## SMITH DOUGLAS - RALEIGH

| TRUSS:             | A2                                         |
| JOB ID:            | 72522022                                   |
| REPAIR ID:         | MII-REP01A1 (ATTACHED)                     |

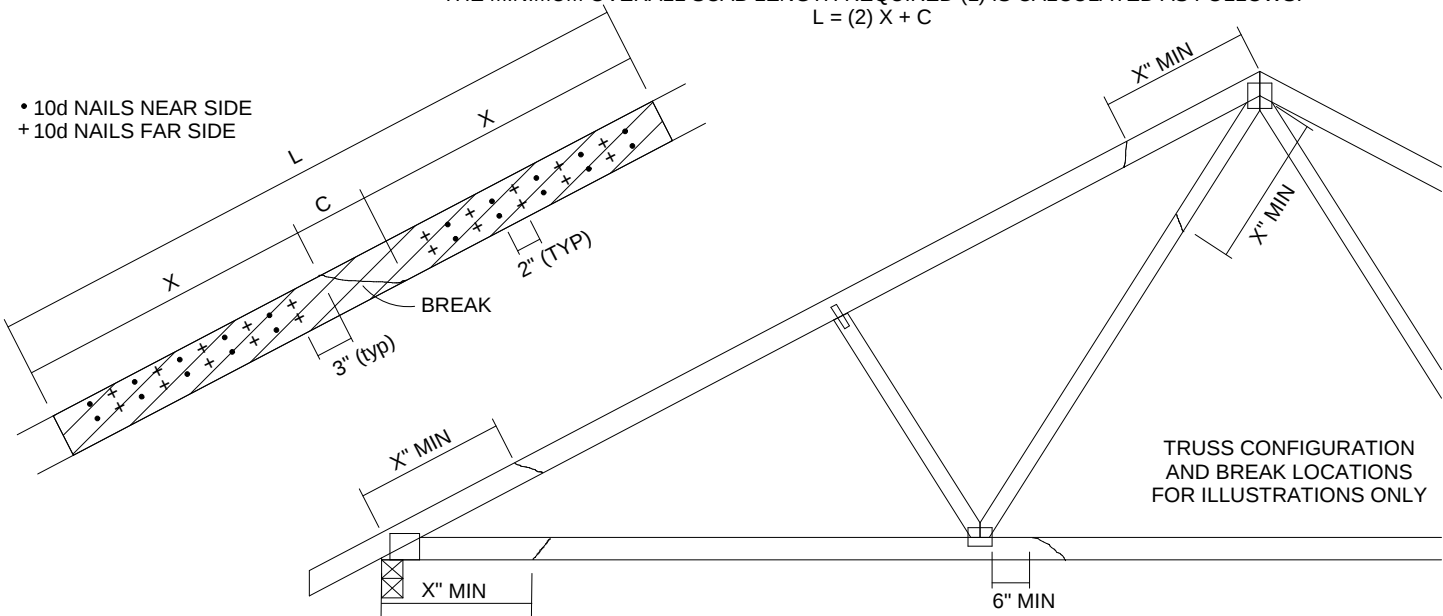
ATTACH 2x SCAB OF THE SAME SIZE AND GRADE AS THE BROKEN MEMBER TO EACH FACE OF THE TRUSS (CENTER ON BREAK OR SPLICE) WITH 10d (0.131" X 3") NAILS (TWO ROWS FOR 2x4, THREE ROWS FOR 2x6) SPACED 4" O.C. AS SHOWN. STAGGER NAIL SPACING FROM FRONT FACE AND BACK FACE FOR A NET 0-2-0 O.C. SPACING IN THE MAIN MEMBER. USE A MIN. 0-3-0 MEMBER END DISTANCE.

THE LENGTH OF THE BREAK (C) SHALL NOT EXCEED 12". (C=PLATE LENGTH FOR SPLICE REPAIRS)

THE LOCATION OF THE BREAK MUST BE GREATER THAN OR EQUAL TO THE REQUIRED X DIMENSION FROM ANY PERIMETER BREAK OR HEEL JOINT AND A MINIMUM OF 6" FROM ANY INTERIOR JOINT (SEE SKETCH ABOVE)

DO NOT USE REPAIR FOR JOINT SPLICES

THE MINIMUM OVERALL SCAB LENGTH REQUIRED (L) IS CALCULATED AS FOLLOWS:

$L = (2) \times X + C$
